HISTORIC AND DESIGN REVIEW
COMPLIANCE AND TECHNICAL ADVISORY BOARD
July 19, 2024

HDRC CASE NO: 2024-152
ADDRESS: 250 QUENTIN DR
LEGAL DESCRIPTION: NCB 6708 BLK 18 LOT 21
ZONING: R-6, H
CITY COUNCIL DIST.: 7
DISTRICT: Monticello Park Historic District
APPLICANT: Mazyar Entezami/ENTEZAMI MAZIYAR
OWNER: Mazyar Entezami/ENTEZAMI MAZIYAR
TYPE OF WORK: Roof reconstruction and modifications, exterior modifications, fencing
APPLICATION RECEIVED: March 29, 2024
60-DAY REVIEW: May 28, 2024
CASE MANAGER: Edward Hall
REQUEST:

Historic and Design Review Commission
Design Review Committee Report

EXISTING/PROPOSED ELEVATION
SCALE: 1/4" = 1'-0"

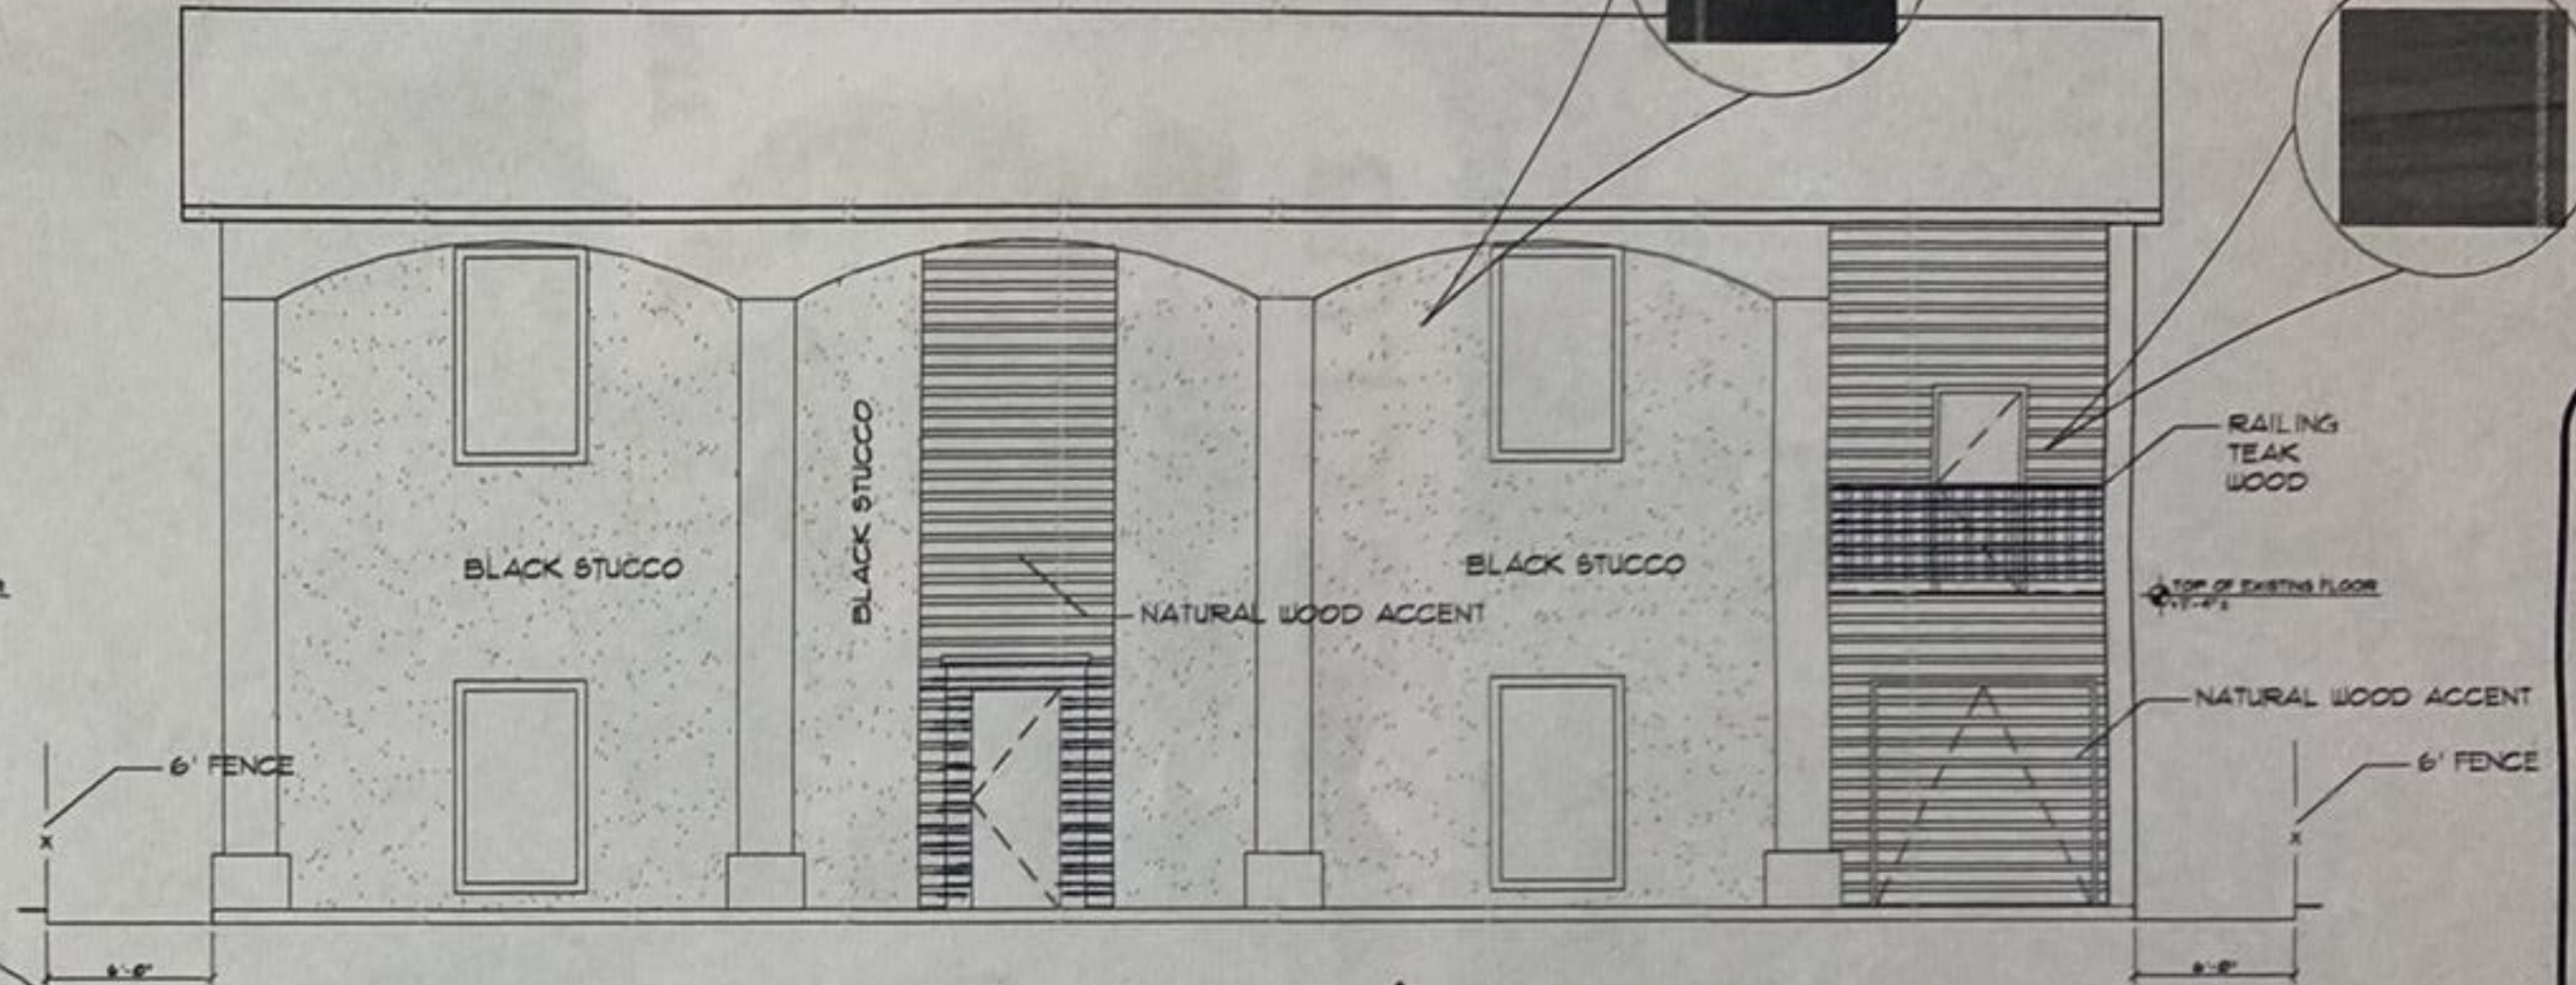
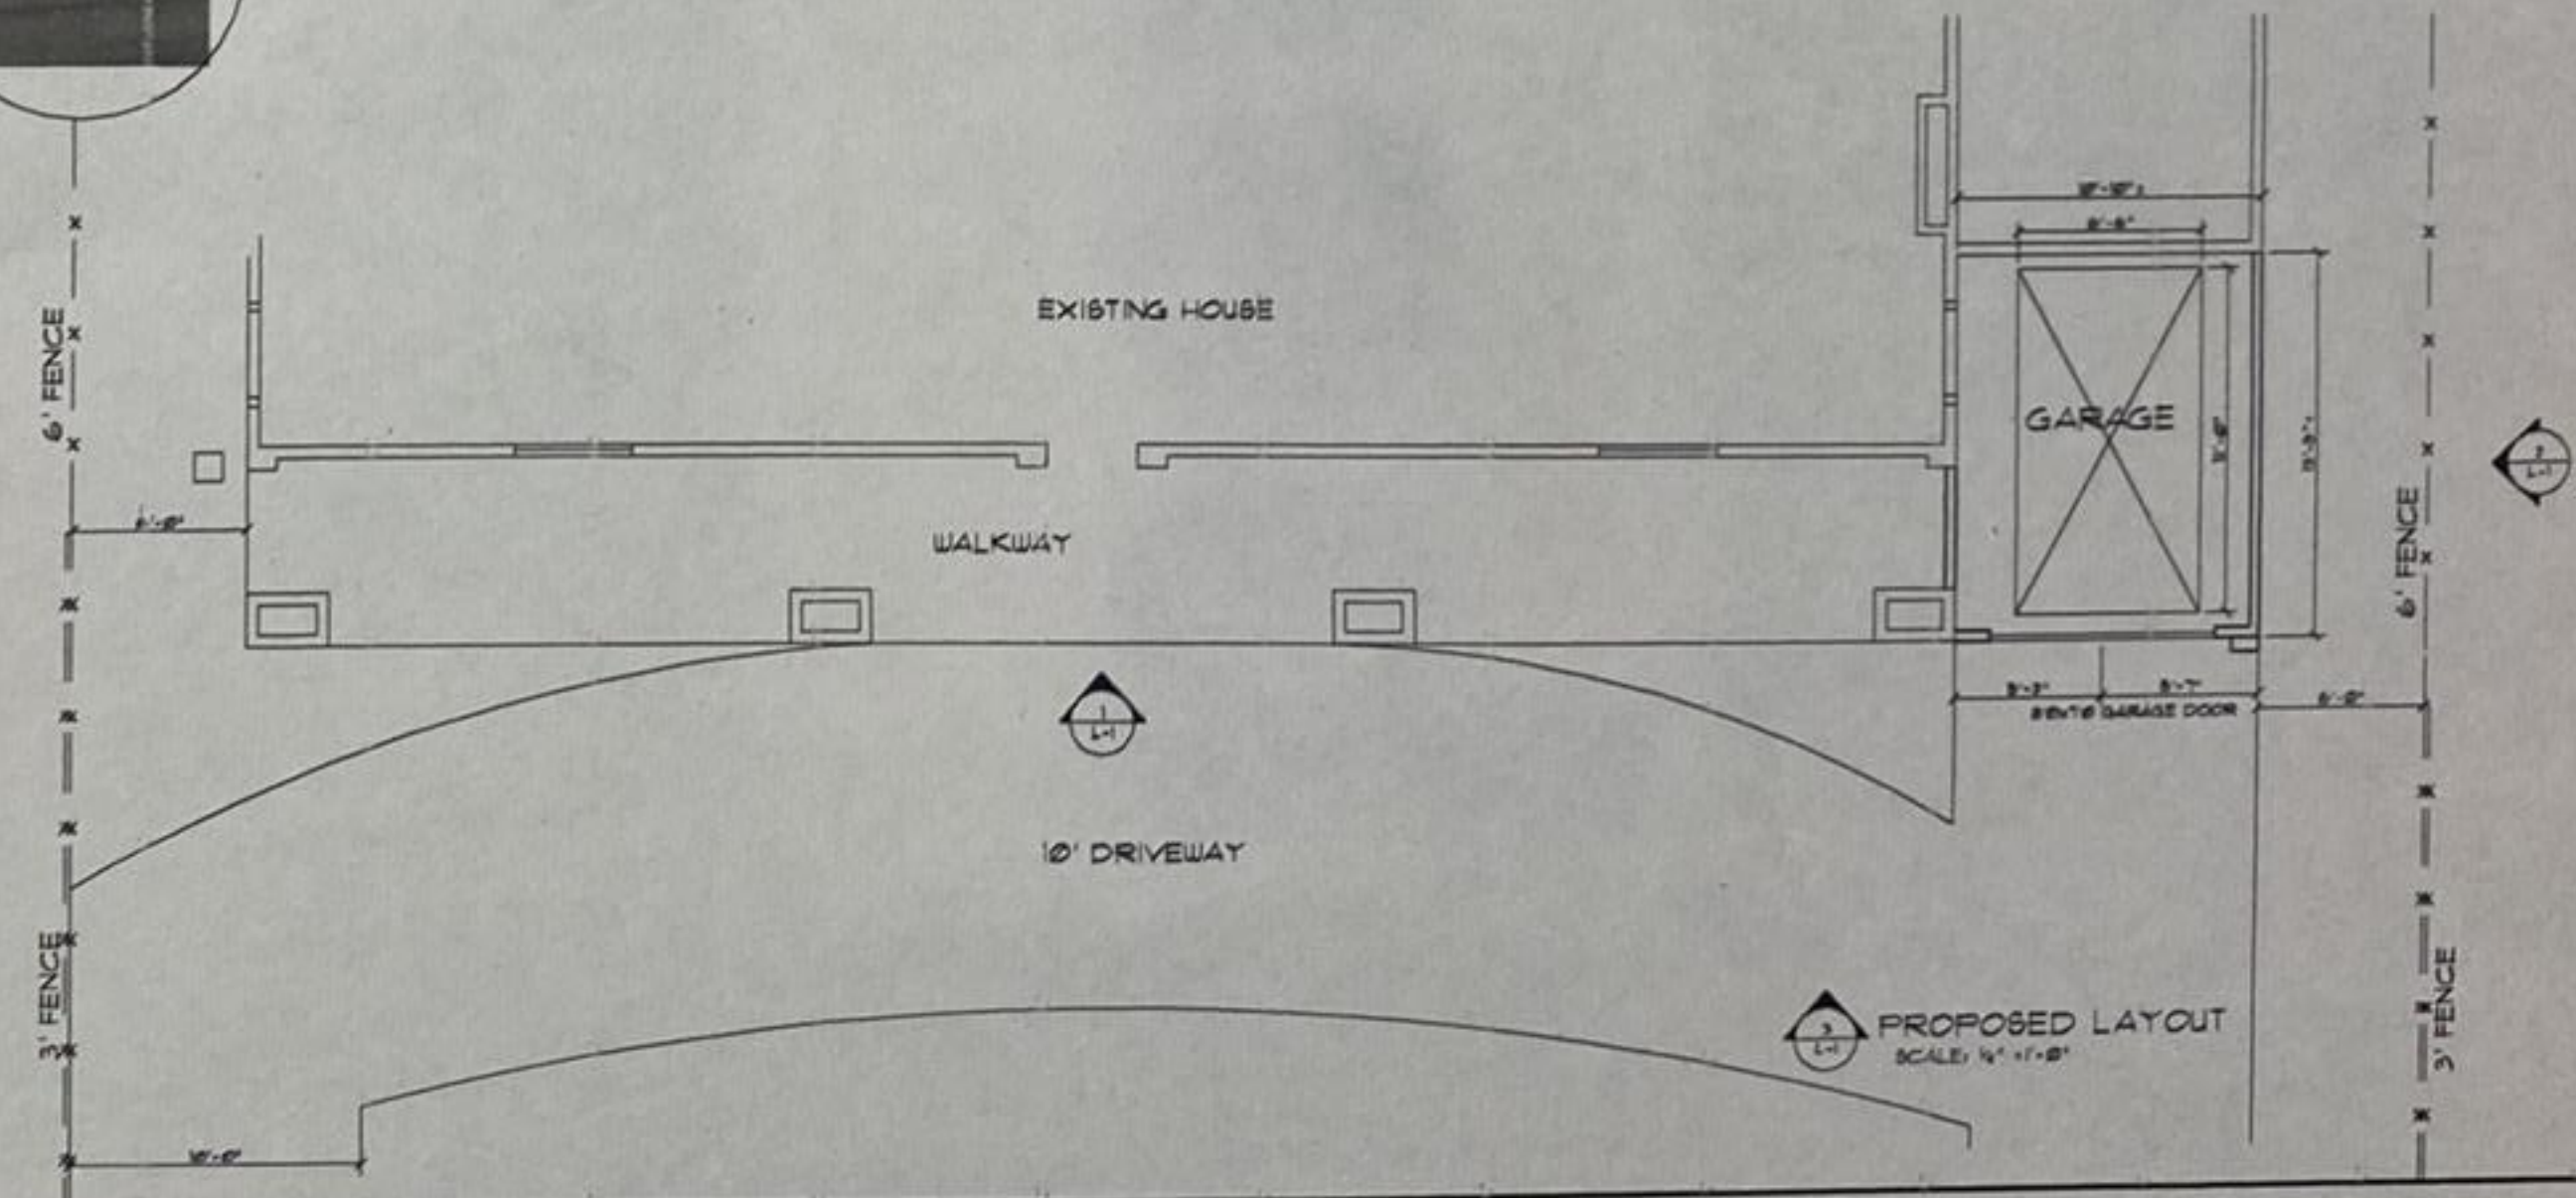
- e. ROOF RECONSTRUCTION – The applicant has proposed to reconstruct the fire damaged roof structure to feature a modified roof pitch and an increased ridge height over an existing side addition. The applicant has not proposed to reconstruct the previously existing chimney. The previously constructed roof featured modifications from the original profile and a modified ridge height. Generally, staff finds the construction of one, centered ridge line to be appropriate; however, staff finds that the side addition should maintain a subordinate ridge height, as was previously constructed. The Guidelines for Additions notes that the roofs of additions should feature subordinate ridge heights.

- f. FAÇADE MODIFICATIONS (Main Structure) – The applicant has proposed to cover the existing, non-original stone façade with black stucco and to add wood siding to feature a natural wood finish. The Guidelines for Exterior Maintenance and Alterations 1.B.ii. notes that modern materials should not be introduced and that materials that match the original in size, scale, and character should be installed. Generally, staff finds the application of stucco and natural wood finish siding to be inconsistent with the Guidelines and historic examples found on this block. Similarly styled and constructed houses feature brick or painted wood siding. Staff finds that the existing façade materials should be maintained and matched or that an architecturally and historically appropriate material be proposed for review and approval. Painting the current façade a traditional color is appropriate. Dark colors, such as black, charcoal or dark gray are not appropriate.

- g. FAÇADE MODIFICATIONS (Side Garage) – The applicant has proposed to modify the façade of the existing, side addition by installing a front facing garage door, a recessed balcony, wood siding and a fifth column. The proposed side addition’s mass will be extended forward to align with the primary façade of the historic structure. The 1941 Sanborn Map notes a garage in the location of the current side addition, where the applicant has proposed to install a garage. Staff finds the proposed request to add a garage door to be appropriate; however, staff does not find the proposal to extend the garage’s footprint forward to be appropriate. Staff finds that the garage’s footprint should remain the same and that the proposed door should feature wood construction or be profiled to appear consistent with those found historically within the Monticello Park Historic District. Staff finds that the façade materials should match the existing on site or that an architecturally and historically appropriate material be proposed for review and approval. Additionally, staff finds that additional construction documents should be submitted to OHP staff for review and approval noting the installation profile and depth of the proposed garage door. Staff does not find the installation of a fifth column to be appropriate.

JV & MS: Reconstructed roof is not appropriate and not in context with the existing examples within the district.

MS: By listening to the conversation at the hearing and by looking at previous photos, the roof as reconstructed is not appropriate. An alternative solution with a reduced ridge height should be considered. Additional comments on solutions that could be explored...lower plate heights, dormers, etc.

JV: Ridge height should be decreased.

- 1. Staff recommends approval of item #1, the reconstruction of the roof structure with the following stipulations:
 - i. That the side addition should maintain a subordinate ridge height, as was previously constructed.

- 2. Staff does not recommend approval of item #2, the installation of black stucco and unpainted wood siding on the façade as noted in finding e. Staff recommends the existing façade materials be maintained and matched or that an architecturally and historically appropriate material be proposed for review and approval.

- 3. Staff does not recommend approval of the request items identified in item #3, as they have been proposed, based on finding g. Staff recommends the following:

- i. That the proposed garage’s footprint remain as it currently exists and not be brought forward.
 - ii. That the façade materials should match the existing on site or that an architecturally and historically appropriate material be proposed for review and approval. The proposed unfinished wood siding is not appropriate.

- iii. That additional construction documents be submitted to OHP staff for review and approval noting the installation profile and depth of the proposed garage door.

- iv. That the proposed fifth column be eliminated.
- 4. Staff does not recommend approval of item #4, fencing, as proposed. Front yard fencing is not found historically on this block of Quentin and is not common within the Monticello Park Historic District. Staff does not find the installation of front yard fencing to be appropriate. Staff recommends approval of privacy fencing, installed behind the front façade of the historic structure. A final site plan noting exact fencing locations is to be submitted to OHP staff for review and approval.
